**NORTH TEXAS MUNICIPAL WATER DISTRICT**  
 LAKESIDE INTERCEPTOR REPLACEMENT

PLAN AND PROFILE  
 STA. 49+00 TO STA. 54+00

BHC PROJECT NO. 2007-104  
 June, 2009

SHEET NO. 14

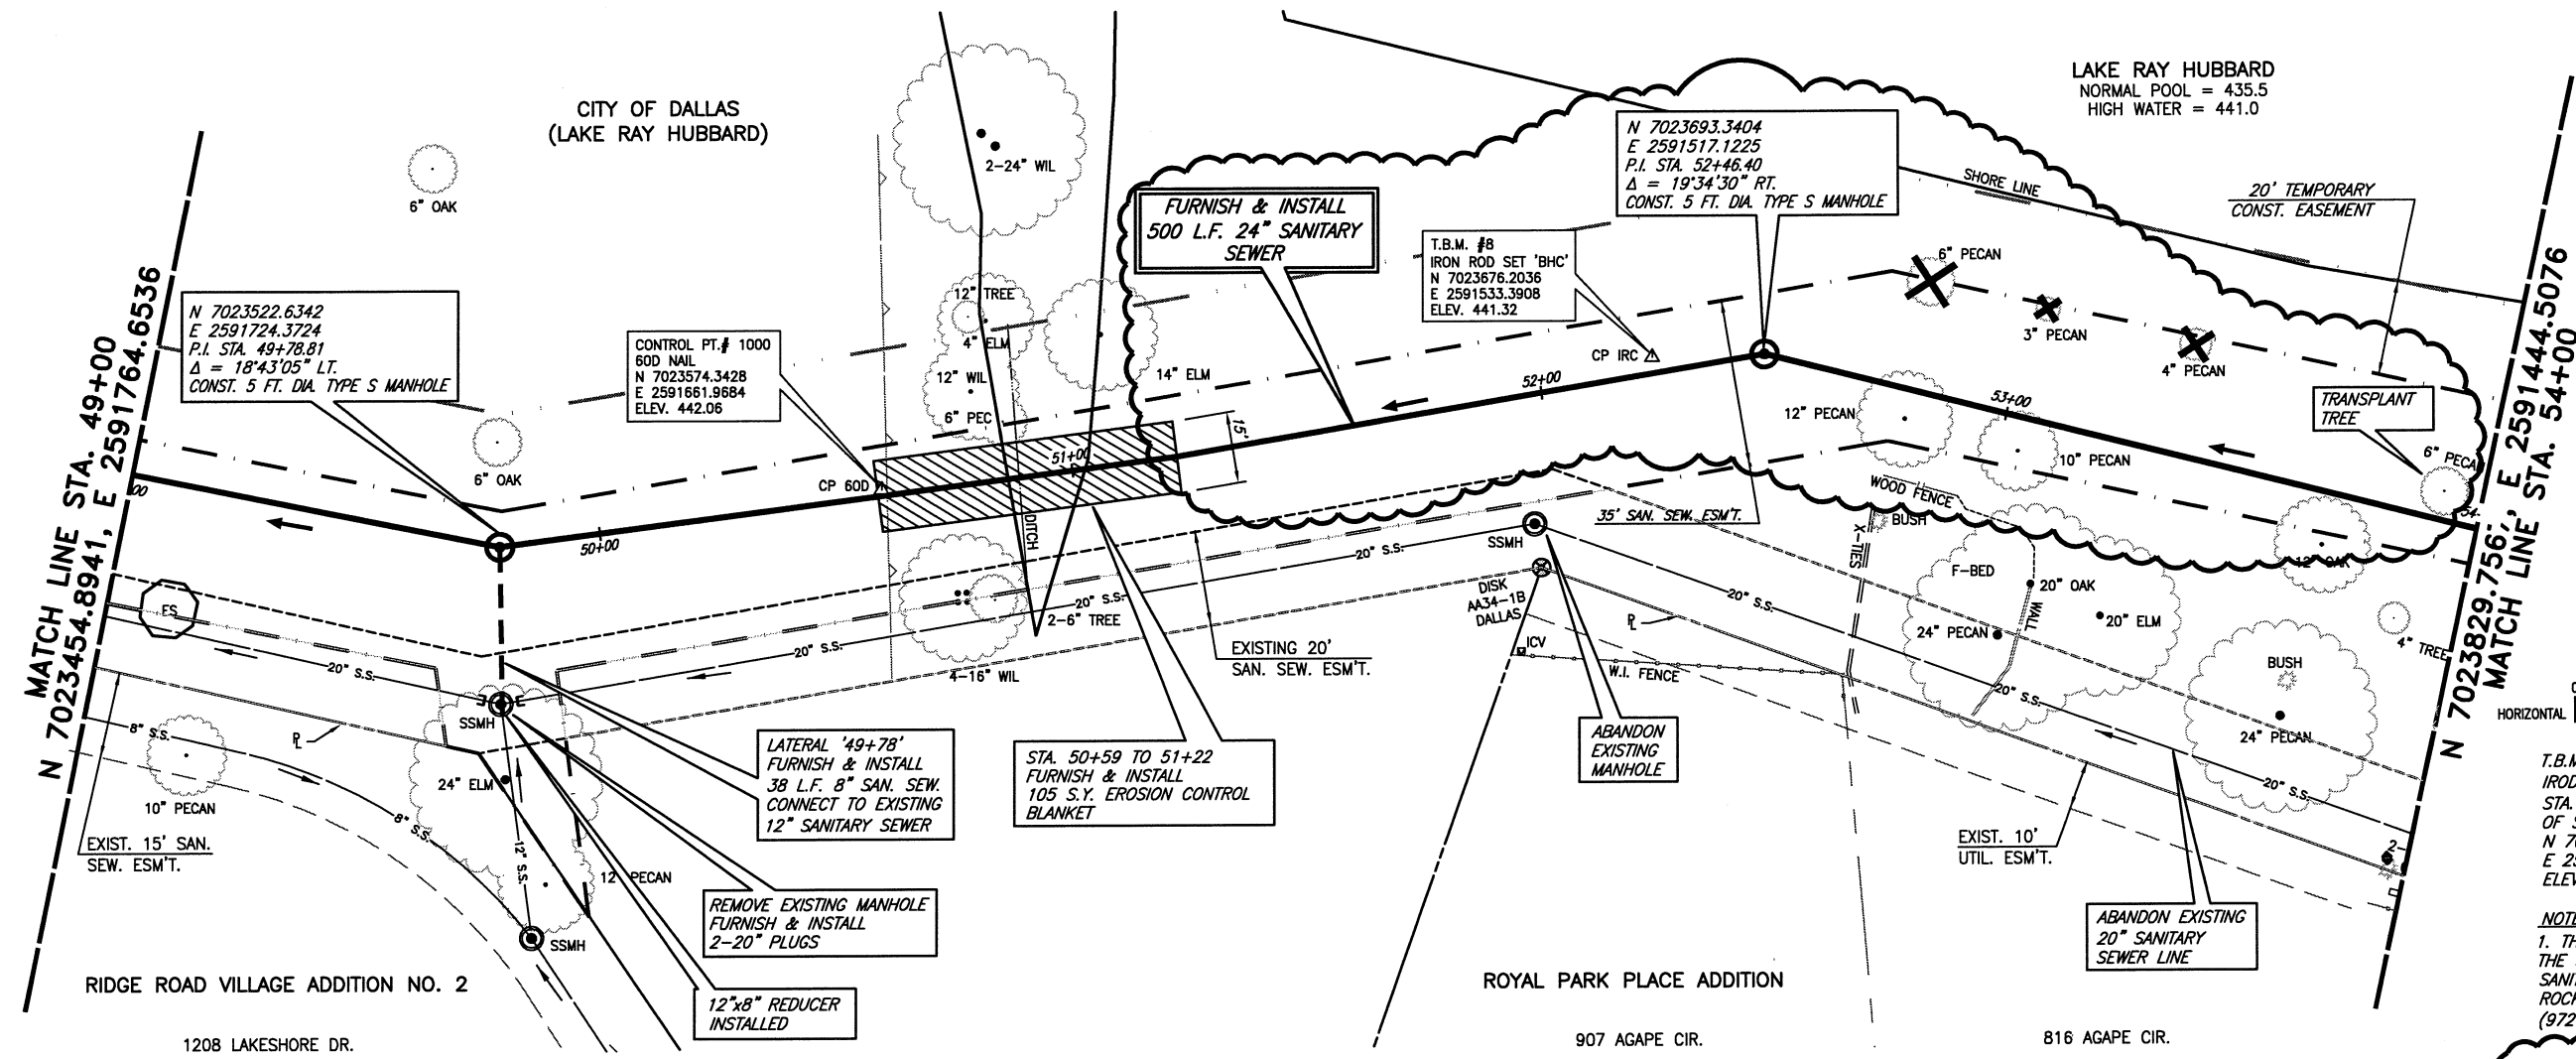
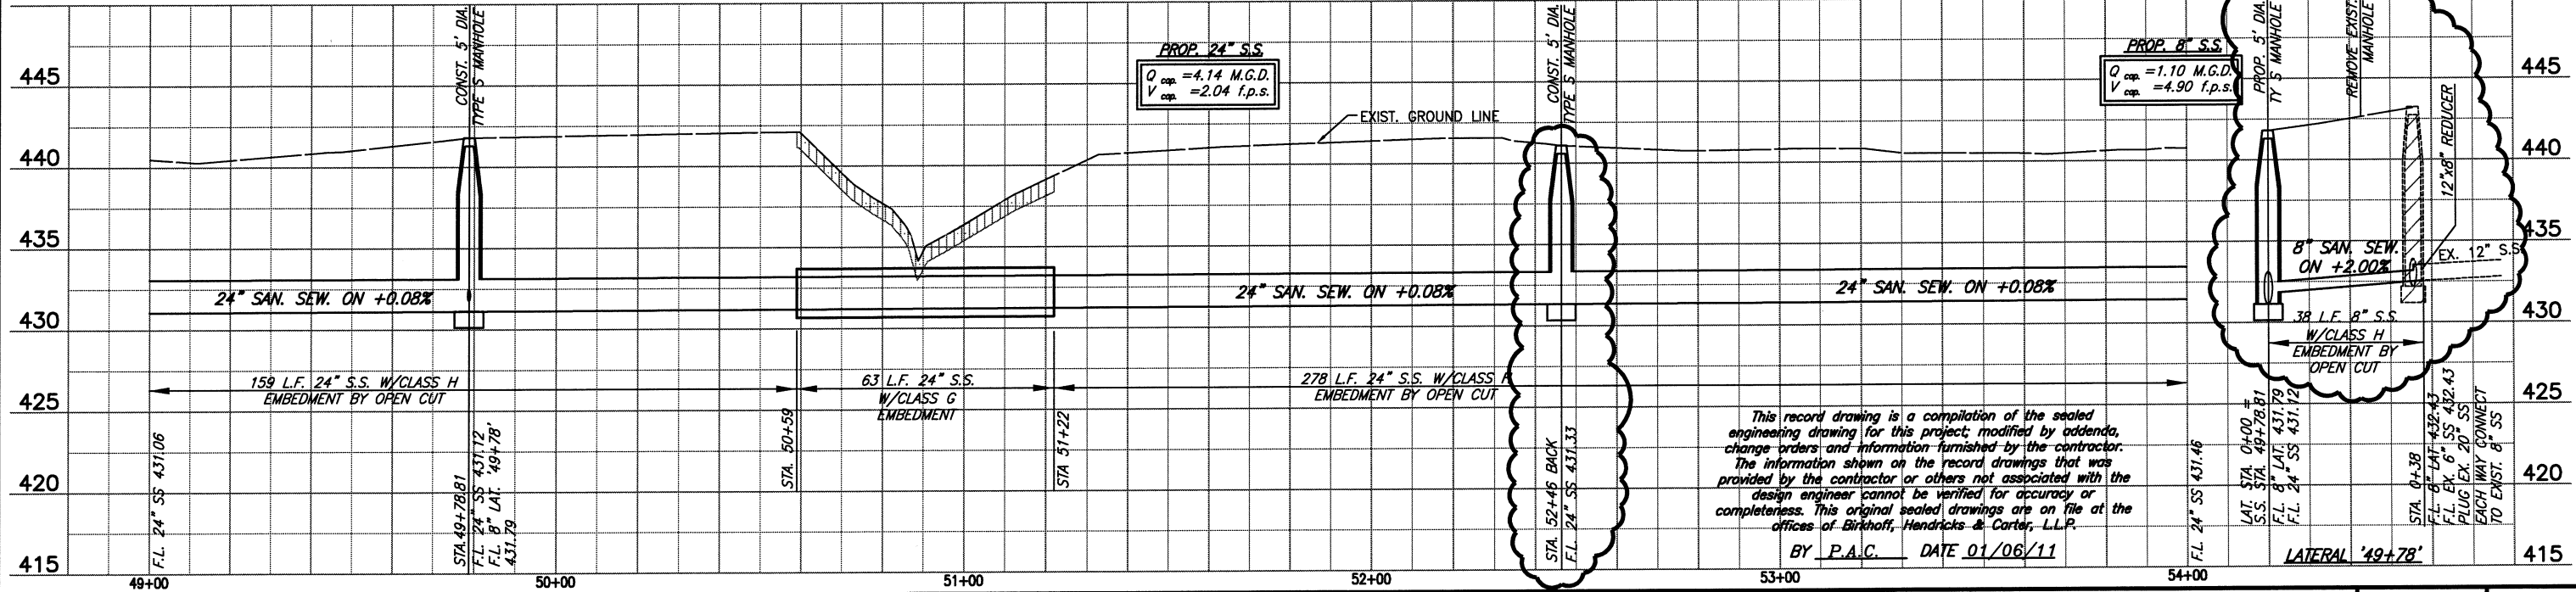
FIELD CHANGE NO.2 2/12/09 - REVISED TREE REMOVAL LOCATIONS
FIELD CHANGE NO.4 6/29/09 - REVISED VERTICAL ALIGNMENT
